ARCHITECT'S SUPPLEMENTAL INSTRUCTIONS

PROJECT:	The Reserves at South Lake New Apartment Complex Grinnell, IA	Report No.	One (1)
OWNER:	OPG South Lake Partners, LLC Dan Maximuk 234 N. Santa Fe Ave, Suite A Salina, KS 67401	Date	Nov. 14, 2022
CONTRACTOR:	MCP Group 3501 SW Fairlawn Rd. Topeka, KS 66614	Architect's Proj No.	20-3118
		Contract For:	General Construction Mechanical, Electrical

VE Items

A BUILDING A NORTH ELEVATION
1/8"=1'-0"

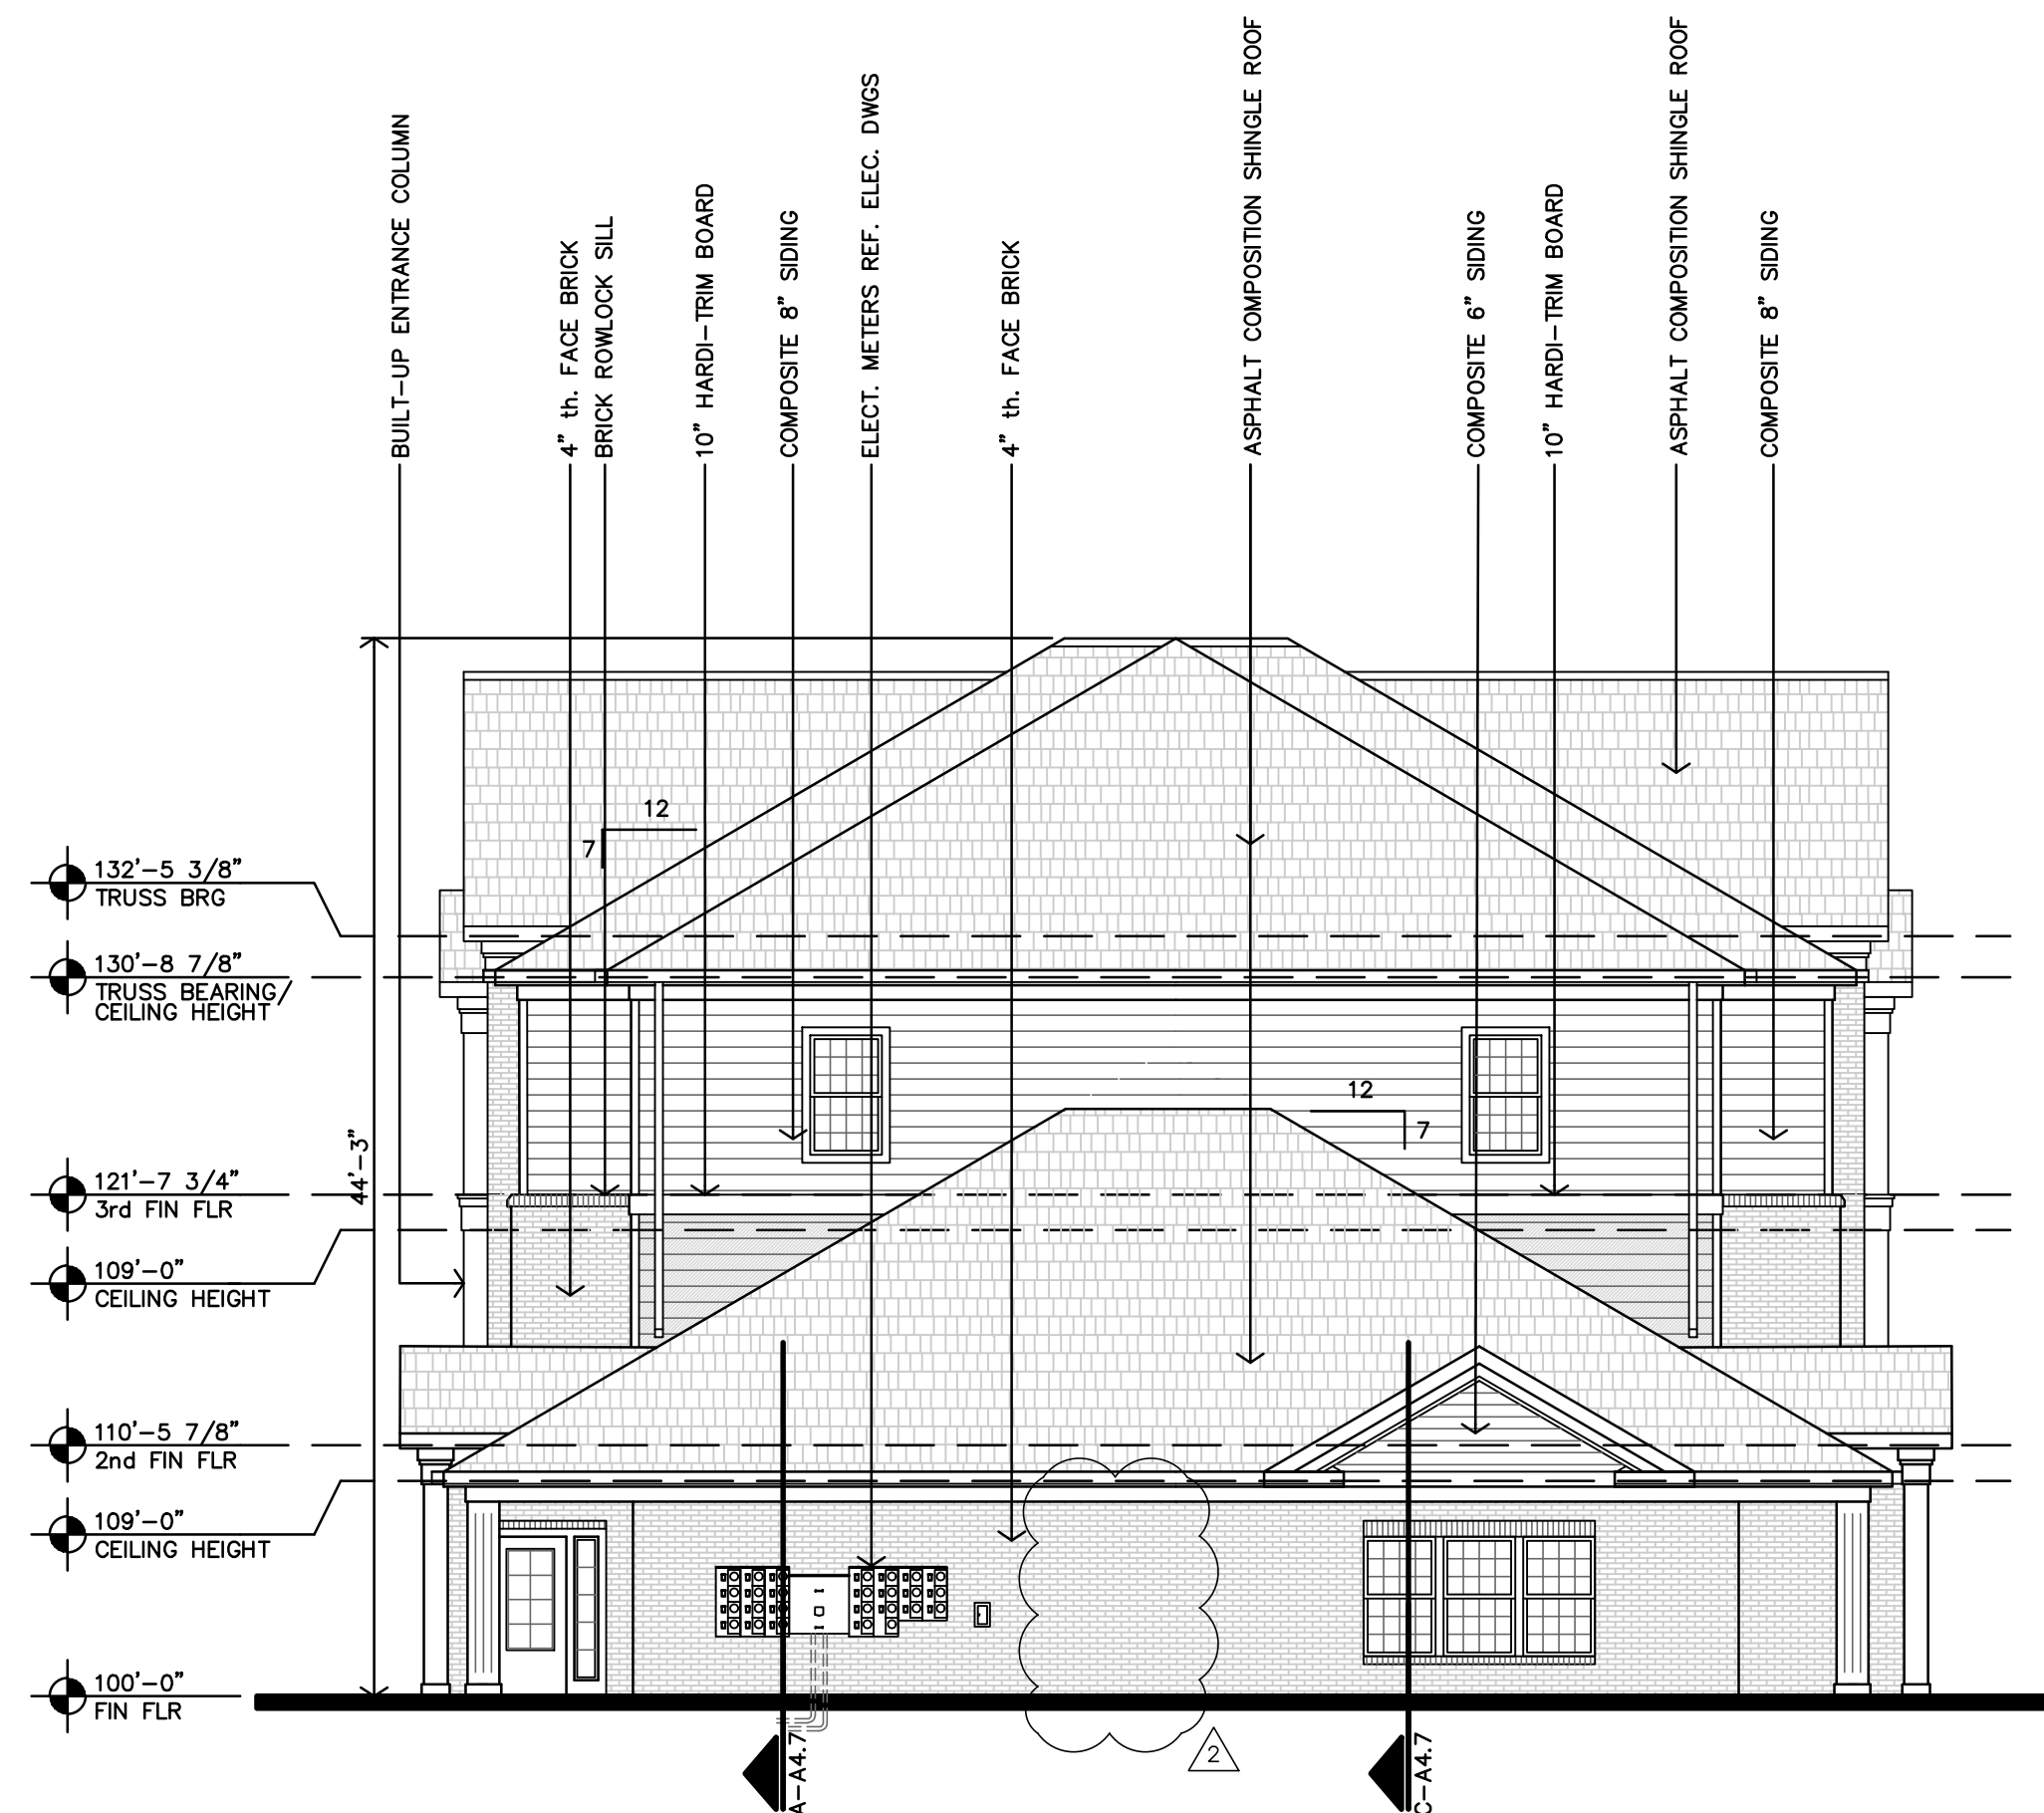
- a. Approx. 1,372sf brick veneer removed. Ref. sheet A3.1 & A3.2
- 5) Delete patio doors & Juliet rails
 - a. Alternate #3 selected.
- 6) All electric
 - a. Alternate #4 selected, Issued per Addendum #2 & #3

S1.1

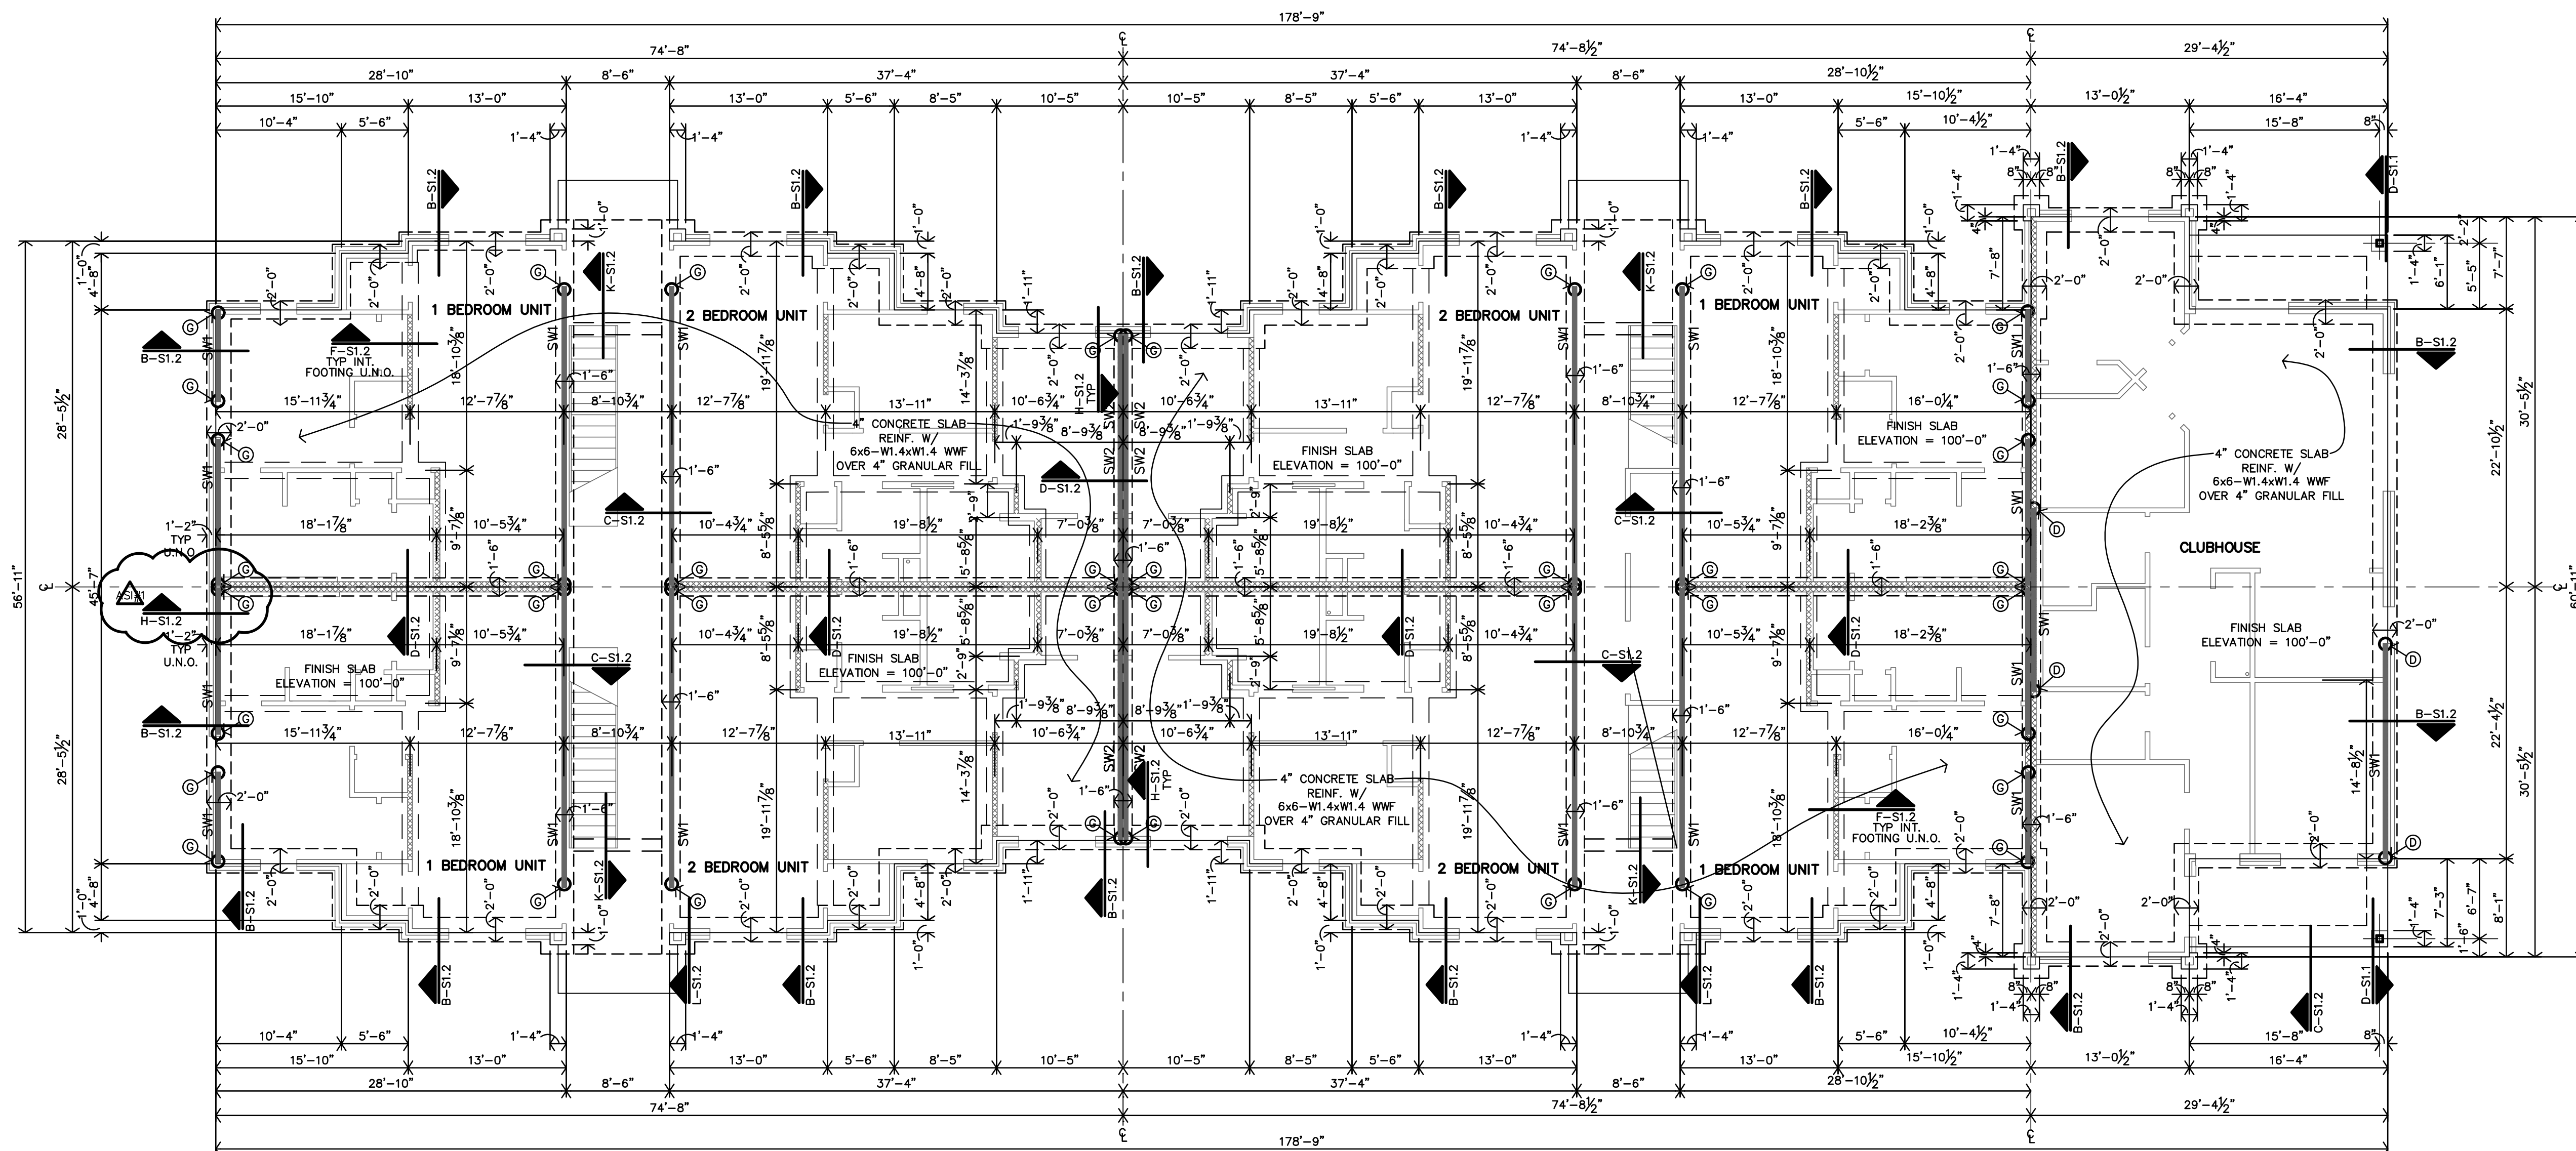
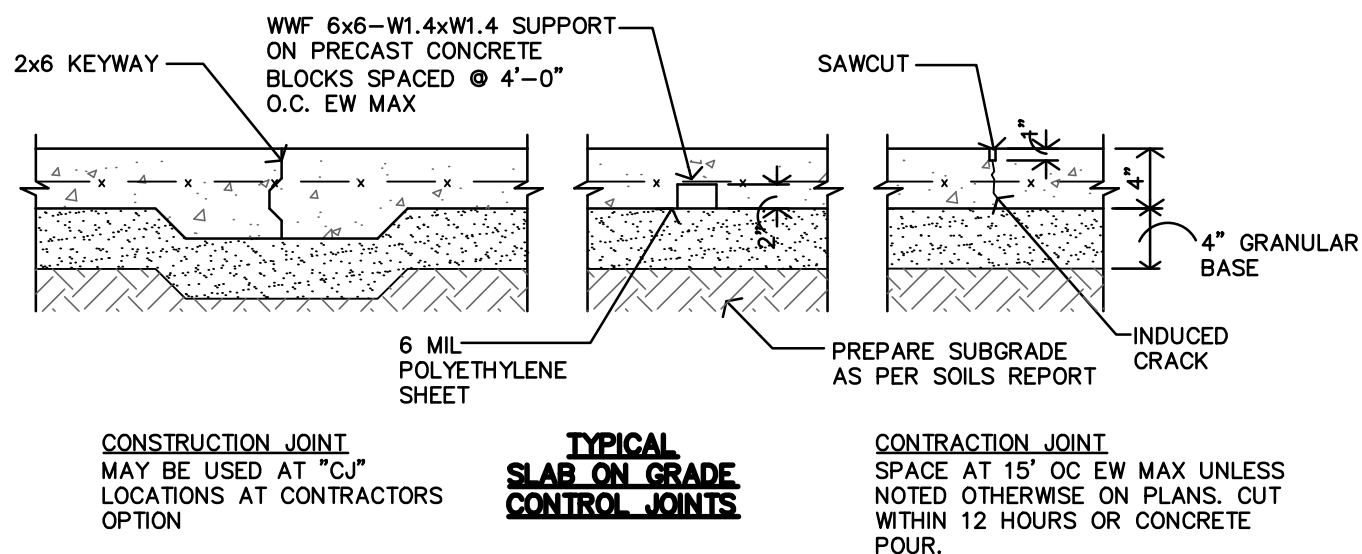
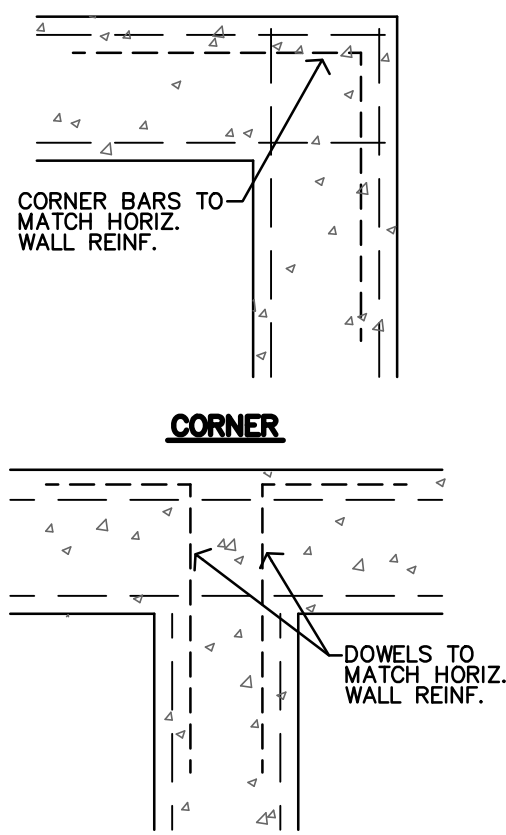
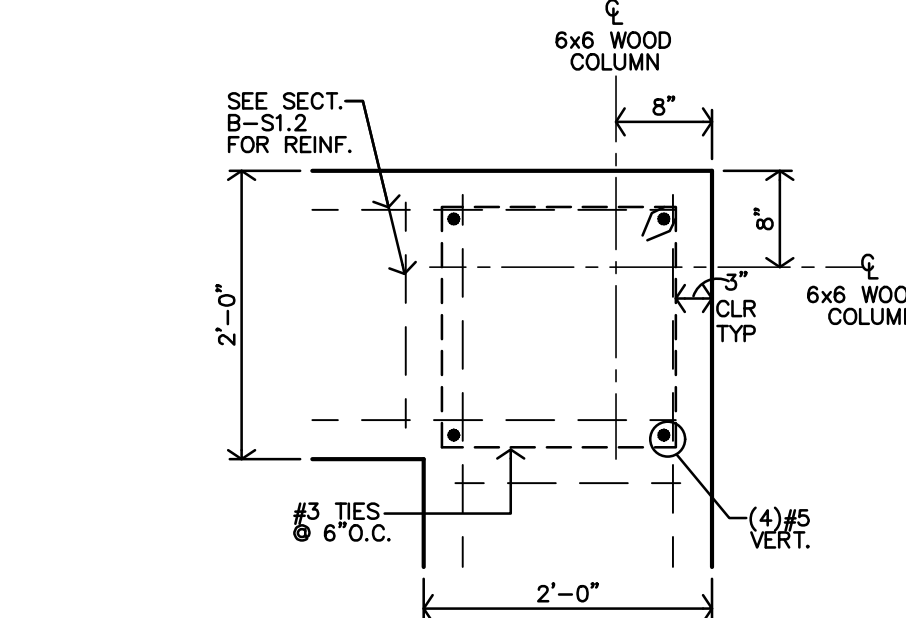
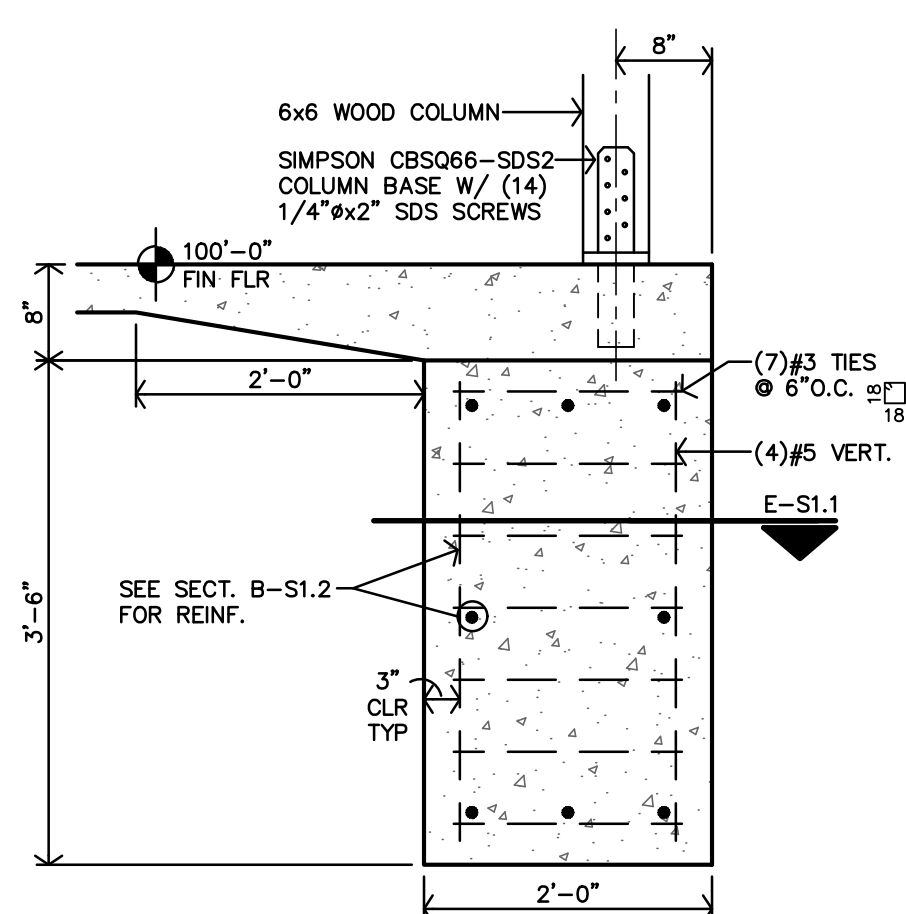
- 1) Change interior slab to 1' thickened slab
 - a. Interior footing revised. Ref. sheets S1.1 & S1.2. Changes to be approved by Energy Consultants.
- 2) Alternate brick Selection
